**Section 16 Application for Partial Conversion of an Existing Commercial Building for Proposed 'Hotel (Student Hostel)' Use at 86 Hung To Road, Kwun Tong, Kowloon**

**Planning Application No. A/K14/838**

**Further Information 2**

**Responses-to-Comments**

Figure 2.1: 500m study area from the Project Building and Identified Potential Air Quality Impact Sources  
 Map Source: (<https://aqia.epd.gov.hk/>)

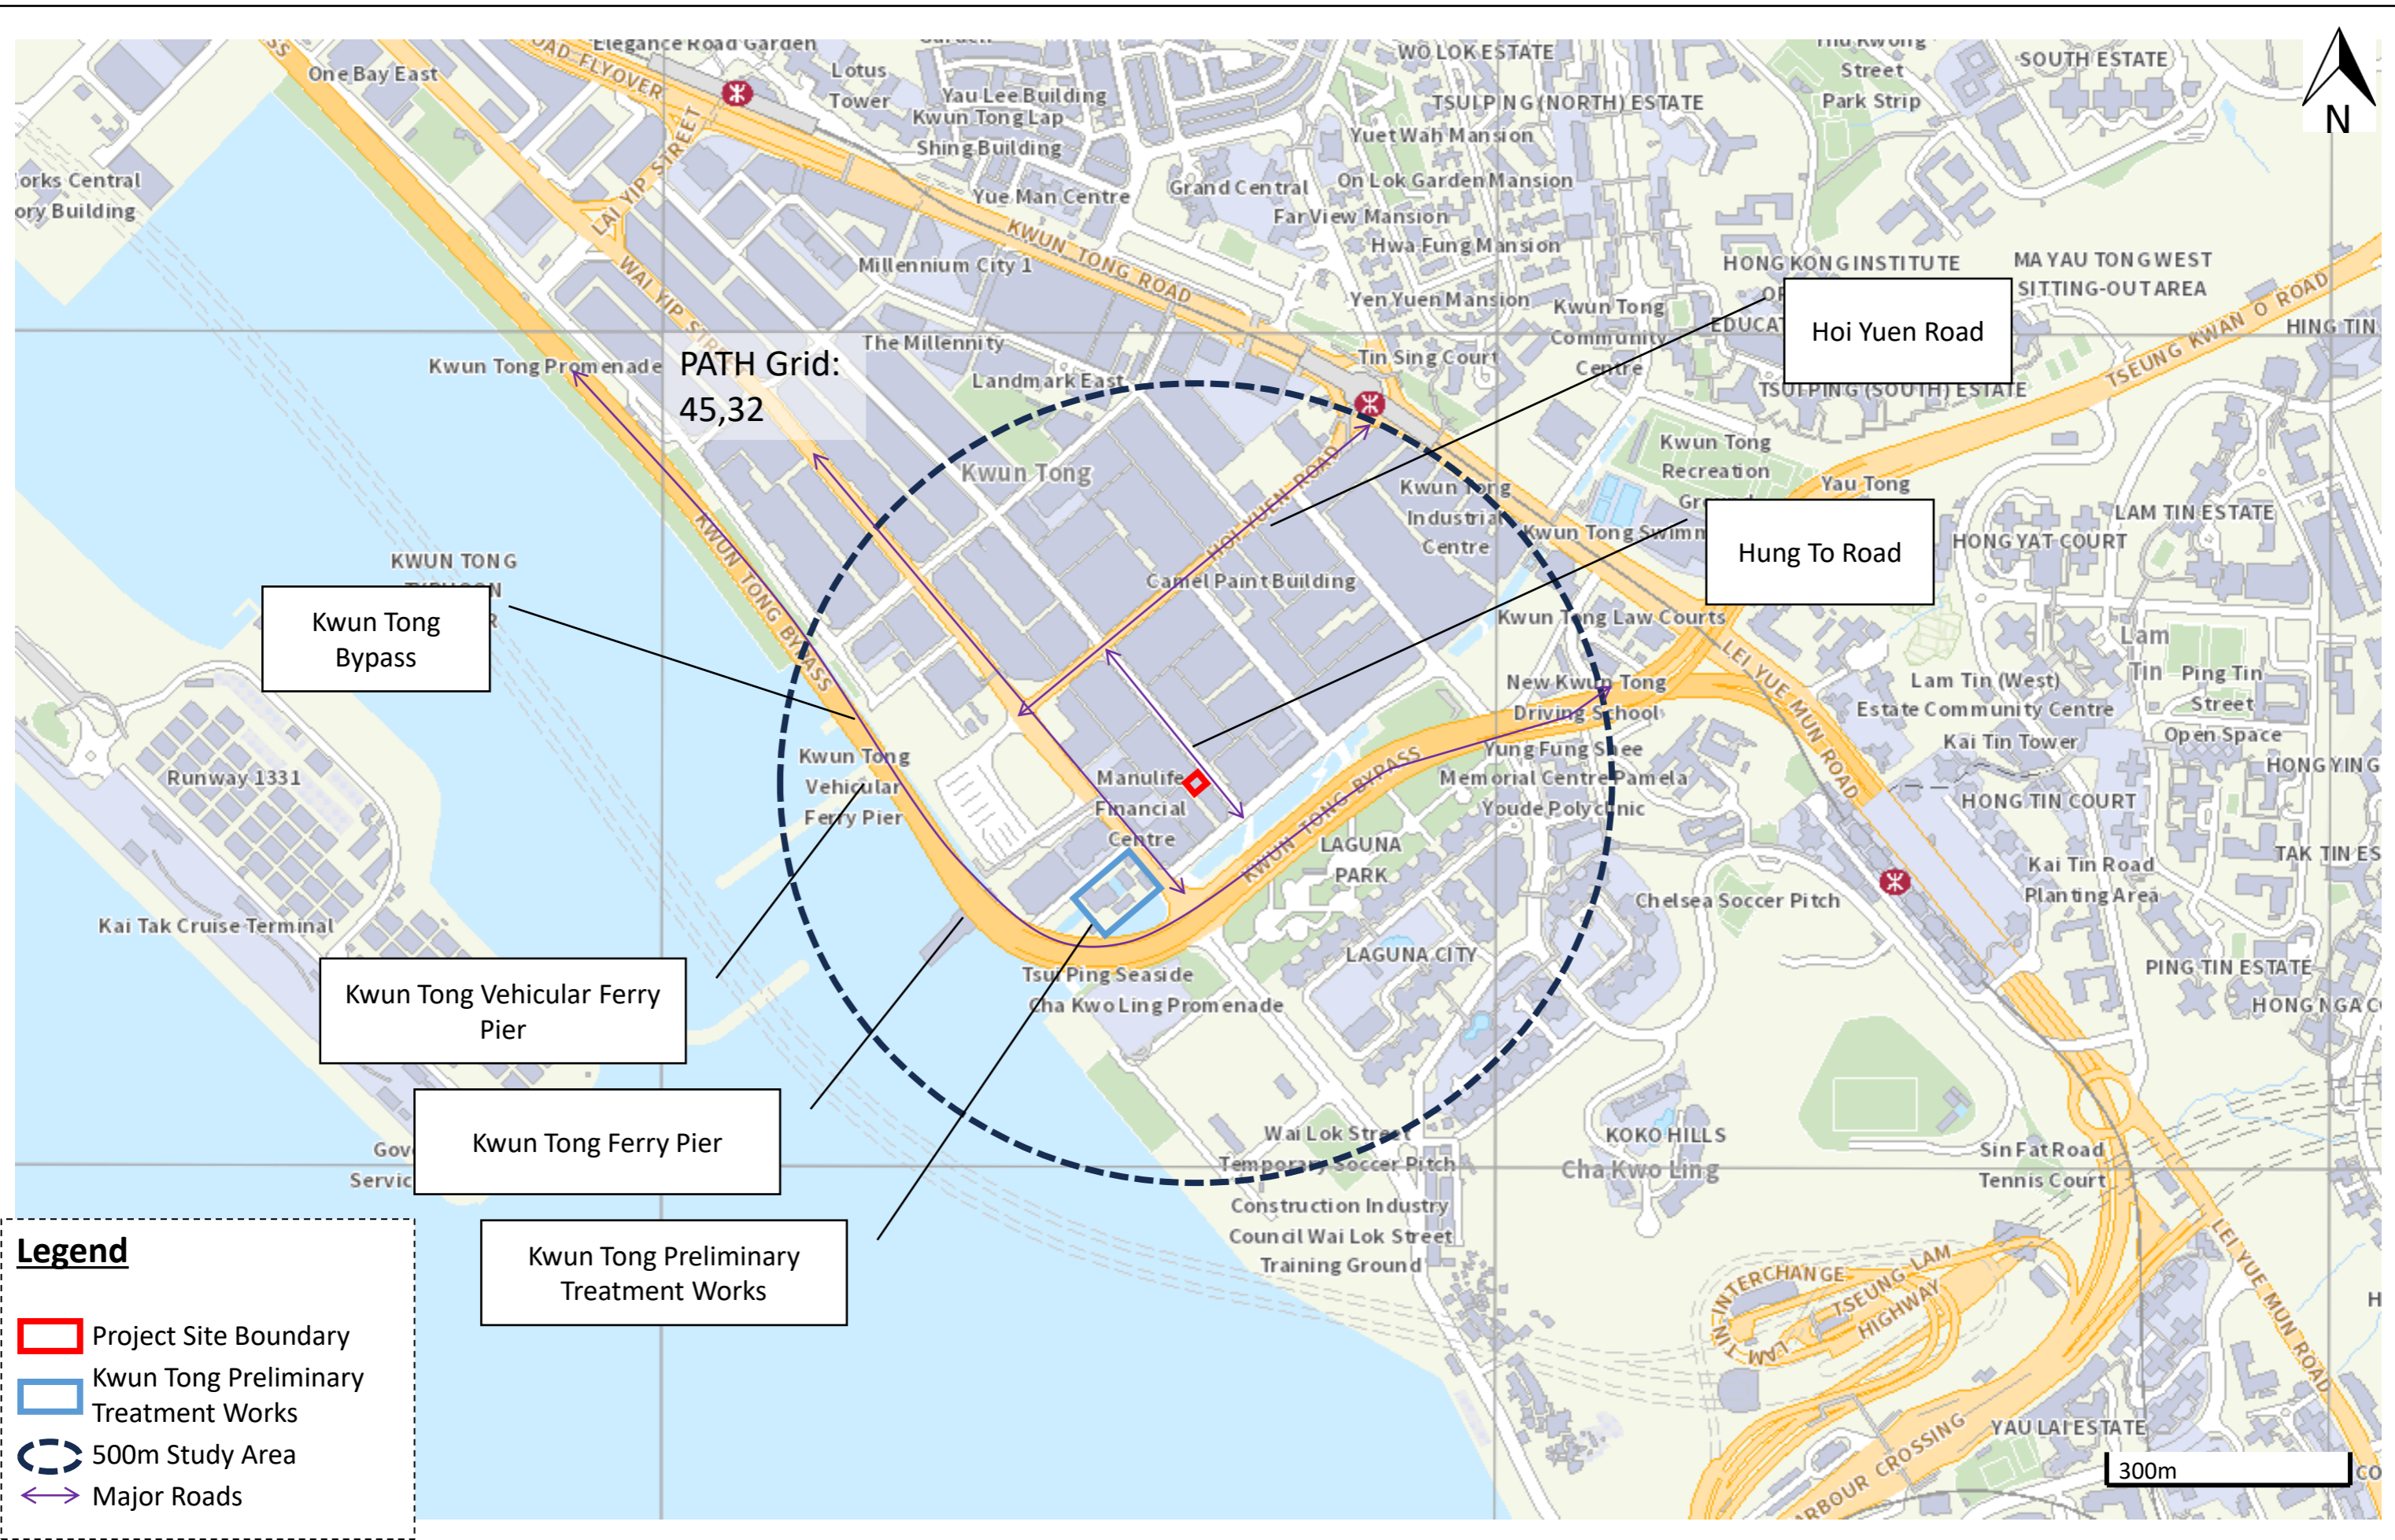
13.	Figure 2.1: Please overlay the PATH grid. Table of Content: Please rectify the table of content for Section 4.	<b>Figure 2.1</b> has been updated accordingly.
<b>Noise Impact Assessment</b>

**Figure 2.2: Identified Air Sensitive Receivers**  
 Map Source: (GeoInfo Map)

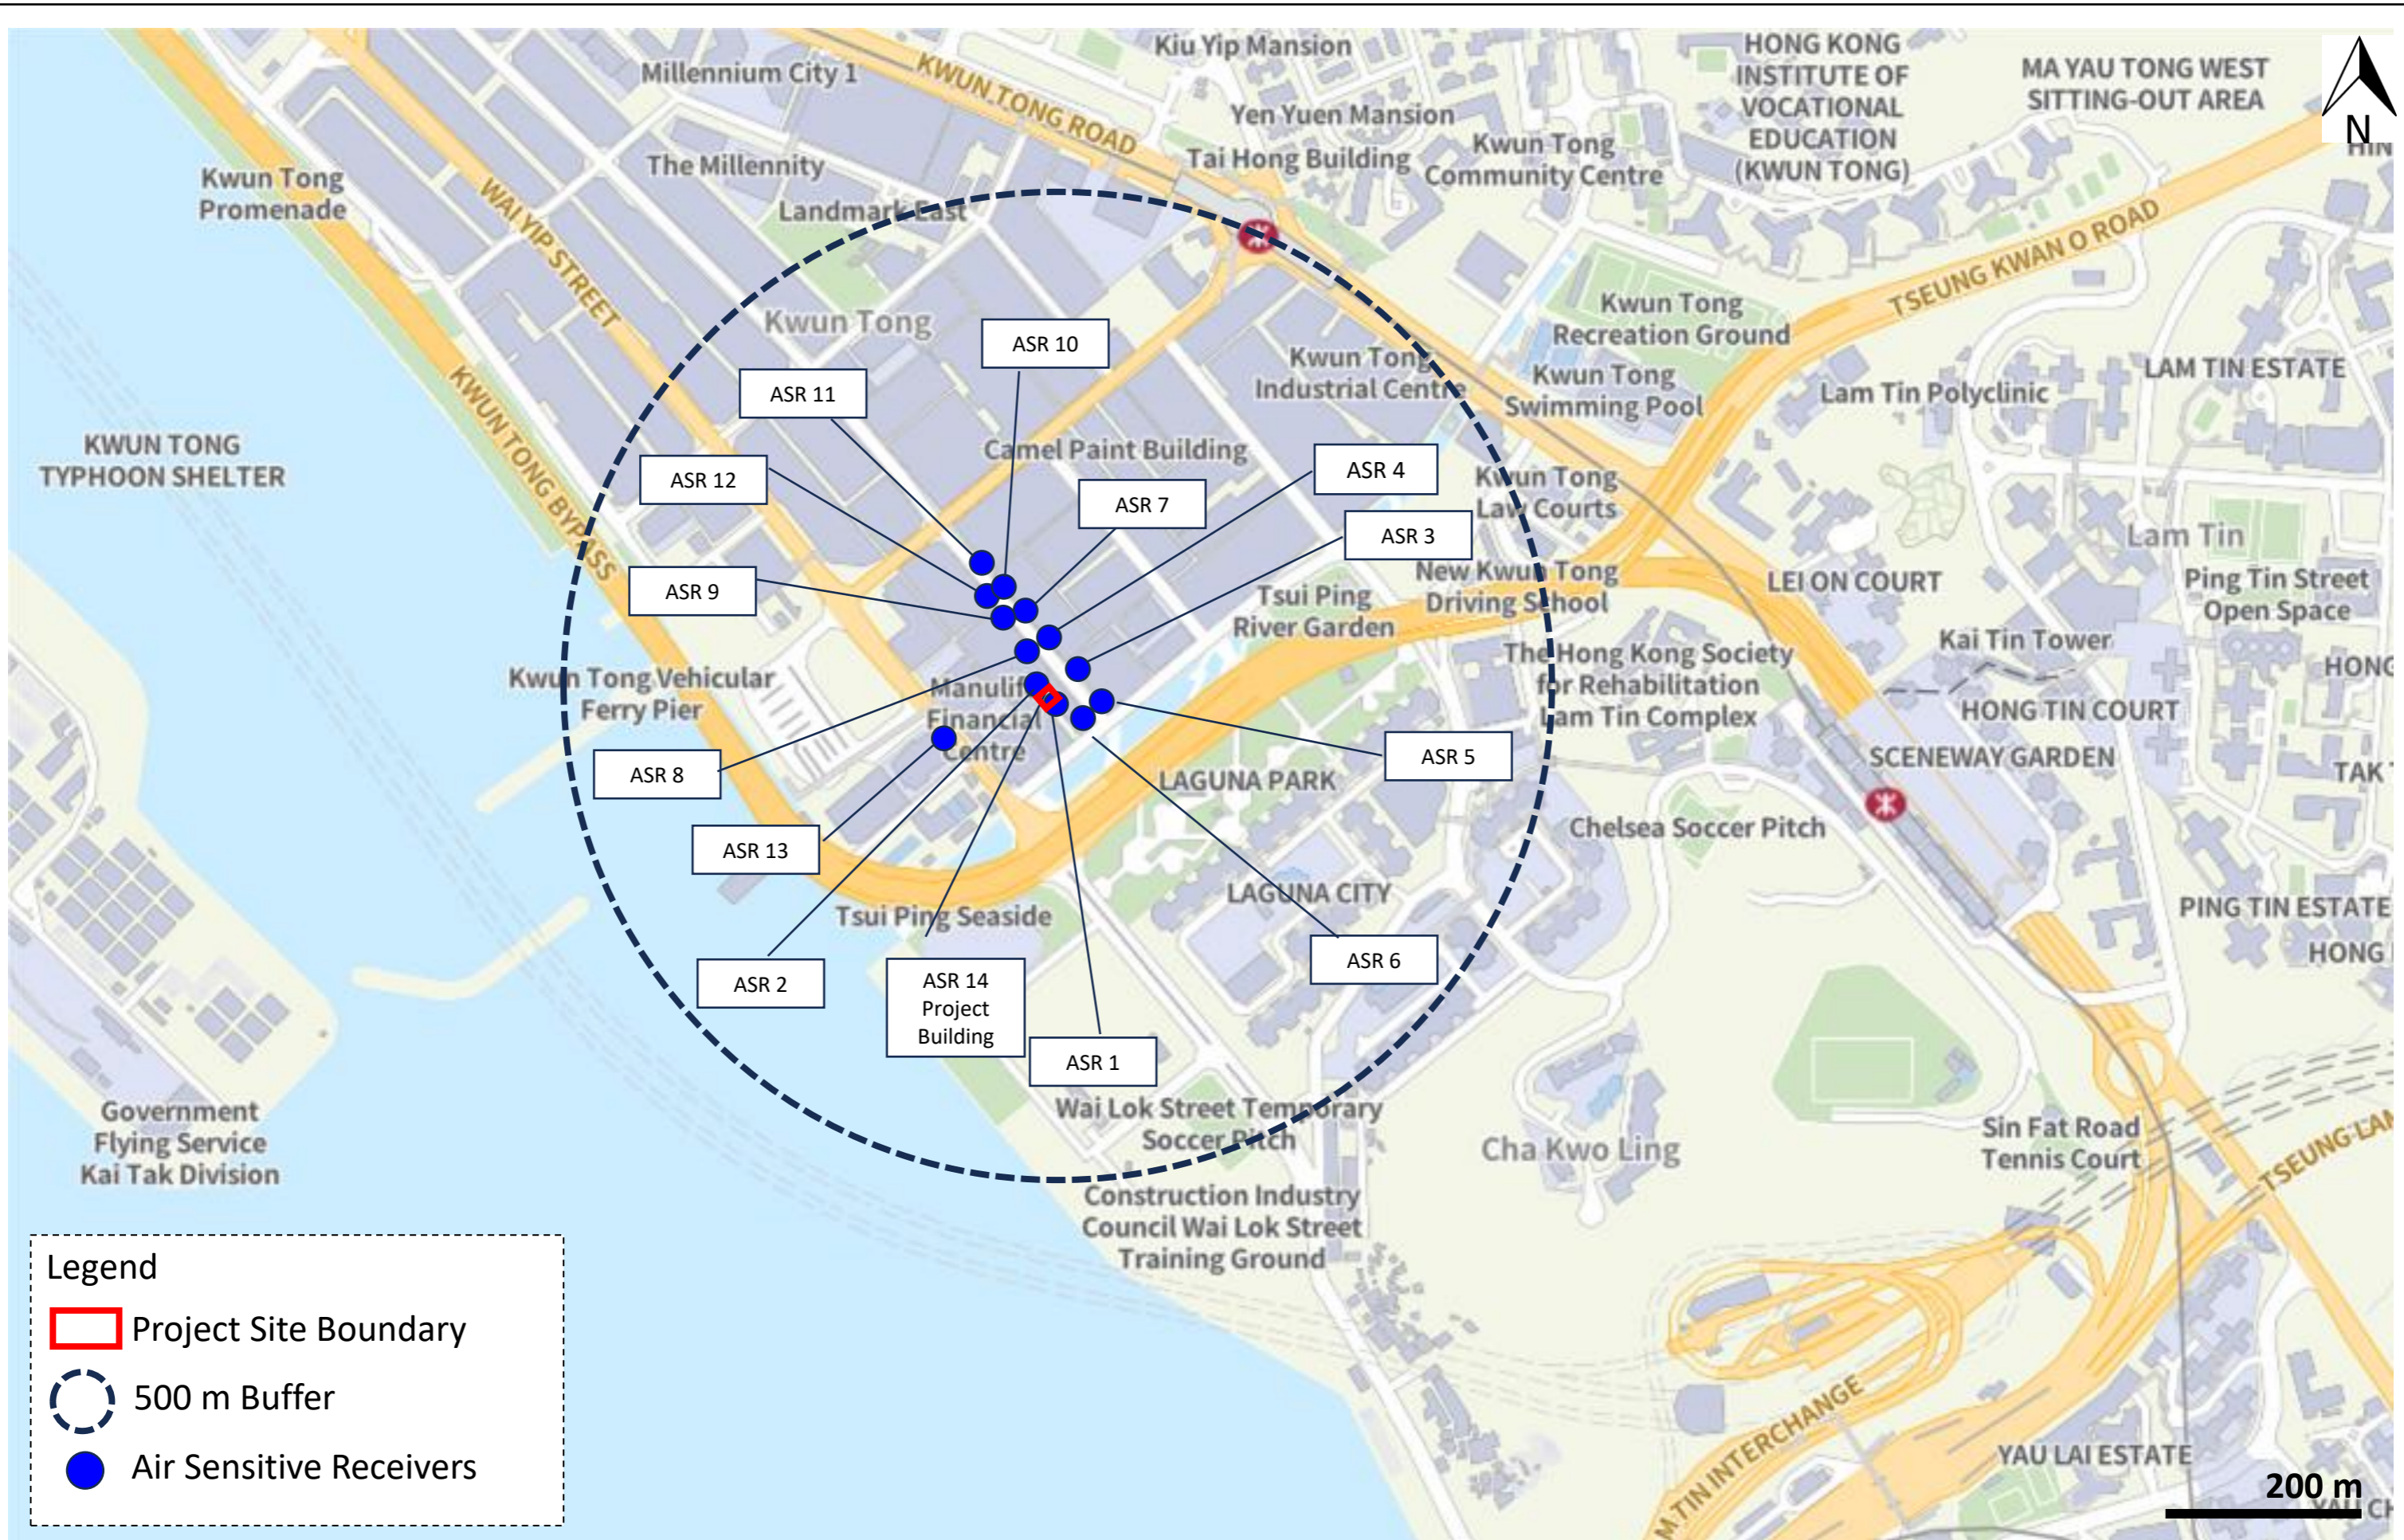
7.	Section 2.2.10: Please supplement a figure indicating the potential ASRs of the site e.g., openable windows and fresh air intakes of air sensitive uses.	Noted. Please see <b>Section 2.2.14</b> and <b>Figure 2.2</b> has been added accordingly.

11	<p>Figure 2.2:</p> <p>(a) There is no "ASR 15" in Figure 2.2. Please check.</p> <p>(b) The ASRs during construction phase should be represented by their nearest locations to the proposed developments. Please revise the locations of the ASRs in Figure 2.2.</p> <p>(c) There is no "Project Site Boundary" in Figure 2.2. Please supplement.</p>	<p>a) Noted. ASR 15 has been removed from <b>Figure 2.2</b>.</p> <p>b) Noted. The locations have been updated accordingly.</p> <p>c) Noted. Project Site Boundary has been added accordingly.</p>
<b>Noise impact assessment</b>		
12	<p>While it was confirmed that the proposed development will be provided with mechanical ventilation system and will not rely on openable window for ventilation, the proposed development will not be subject to adverse traffic noise impact and fixed plant noise impact.</p>	Noted.
